Reviewer #1.

This is a review for "Parameterizing spectral surface reflectance relationships for the Dark Target aerosol algorithm applied to a geostationary imager" from Kim et al. This manuscript extends the well known Dark Target (DT) aerosol retrieval algorithm to the geostationary (GEO) imager ABI on GOES-16 by modifying the so-called Surface Reflectance Parameterization (SRP). This key processing step of the DT algorithm allows it to constrain the spectral variation of surface reflectance as a previous step to the estimation of aerosol properties over dark surfaces. The topic of the manuscript is of high interest for the atmospheric community and very appropriate to AMT because GEO imagers such as ABI are becoming increasingly compelling for aerosol remote sensing thanks to their high revisit time and their increasingly advanced sensing performances. The experiments described in the manuscript are relevant and most of results are convincing. However, and although it reads quite well most of the time, the manuscript would benefit of a careful revision, especially in some sections that are a bit too long (with redundant information) and some others that despite being key are a

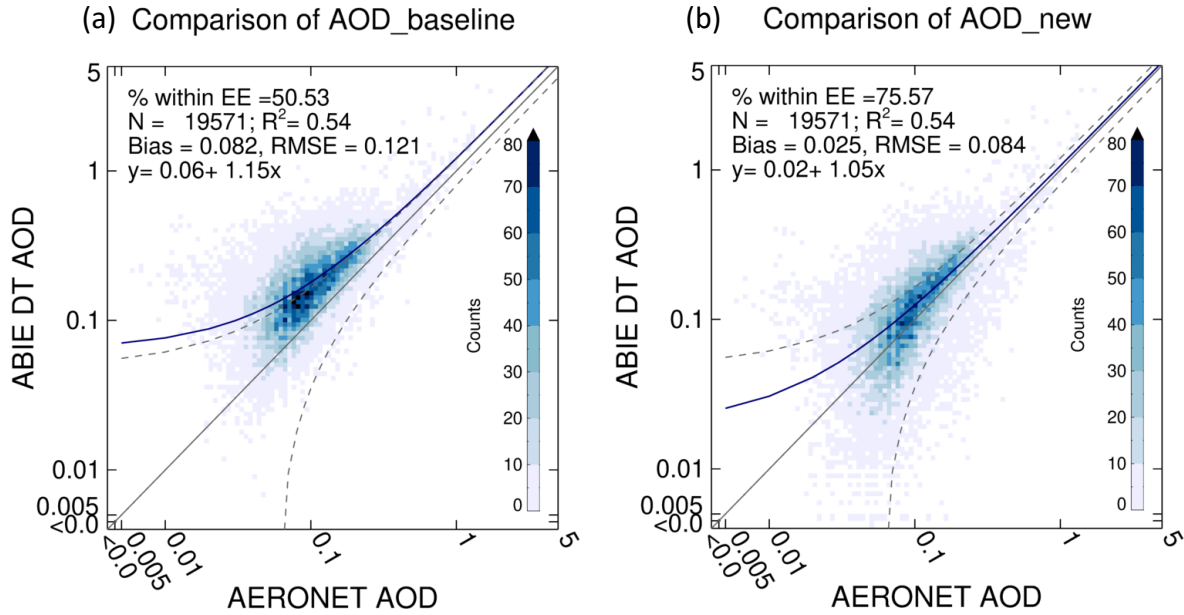
-Sect. 6.3: I would like to see some AERONET/DT density scatter plots, with some average statistics.

We agree with this comment and have added DT AOD validations (Fig. 19 and description on lines 618-625).

*“The scatter plots in Fig. 19 compares the DT AODs with AERONET AOD. By applying the new SRP, the %EE has been improved from 50.53% to 75.57%, and the regression slope became closer to 1. Figure 20 shows the same plots as seen in Figure 17 but for three specific AERONET site, GSFC, NEON Harvard, and PNNL, which are dominated by Urban (44.09%), mixed forests (47.57%), and Croplands (86.87%), respectively. The AERONET sites are observed from ABIE with fixed VZA of 45.42°, 49.38°, and 68.99°, respectively. The new SRP reduces the AOD bias at the three AEROENT site but has less impact on the mitigation of the time-dependence at PNNL. The AOD retrieved at PNNL may have greater uncertainty in that the site is located at the high VZA near the boundary of ABIE’s observing disk, and the cropland surface contributed to the bright reflectance. “*
